Wisconsin Department of Transportation

Proposal #48: 8100-01-72, WISC 2026164
Menomonie - Ridgeland
IH 94 to CTH D
STH 25
Dunn County

This is Addendum No. 01, which provides for the following:

Addendum No. 01
ID 8100-01-72
Revised Sheet 91
January 9, 2026

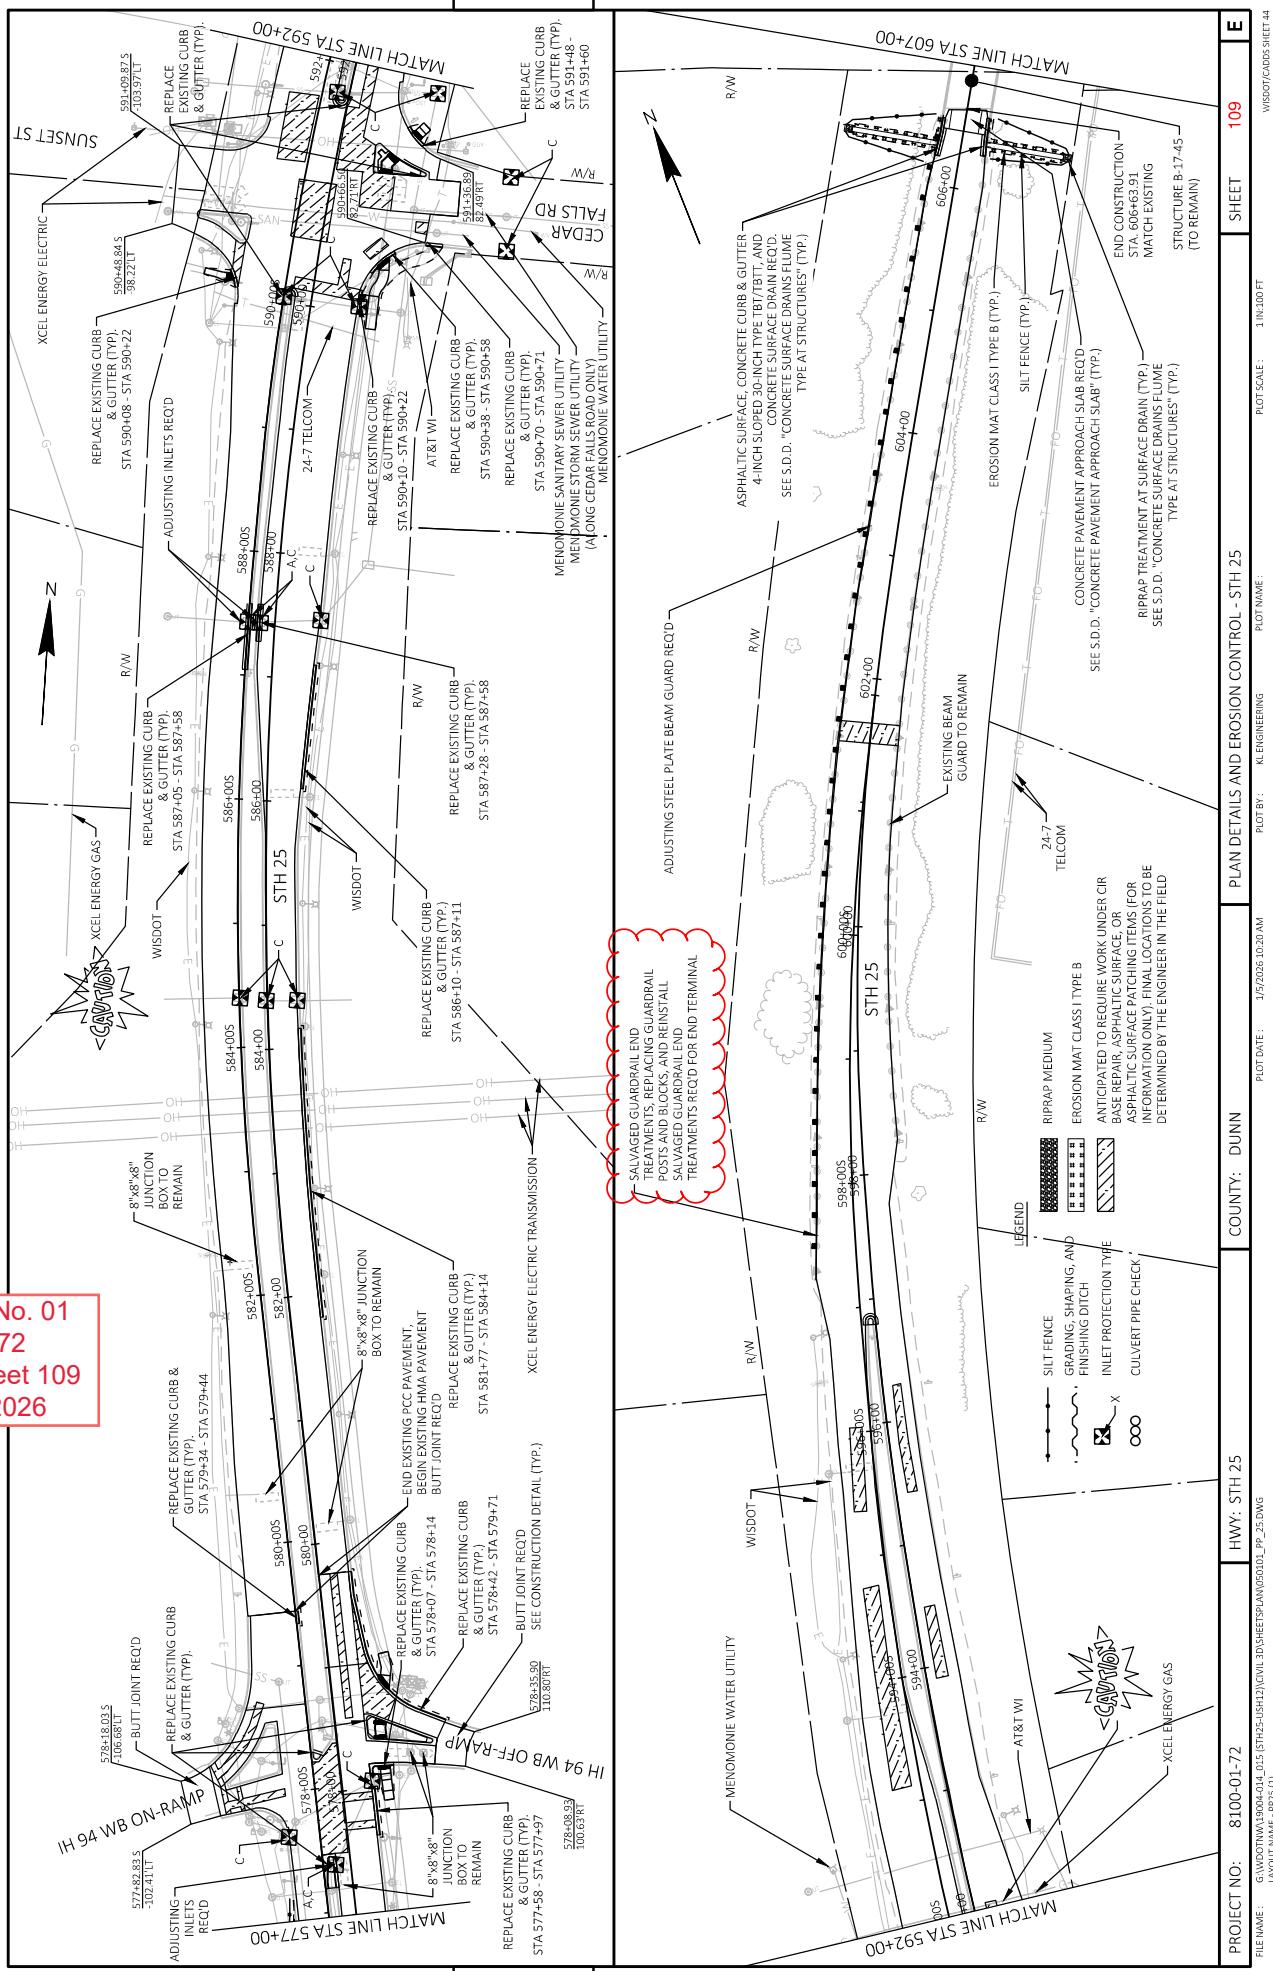
Revised Plan Sheets	
Plan Sheet	Plan Sheet Title (brief description of changes to sheet)
12, 14	Finished Typical Sections (Updated typical section notes for beam guard work)
25	Intersection Details (Updated note for signal loop pavement)
91	Miscellaneous Quantities (Updated earthwork quantities for approach slabs)
97	Miscellaneous Quantities (Updated beam guard quantities for item changes)
109, 111, 113, 114, 115	Plan Details and Erosion Control (Updated notes for beam guard work)
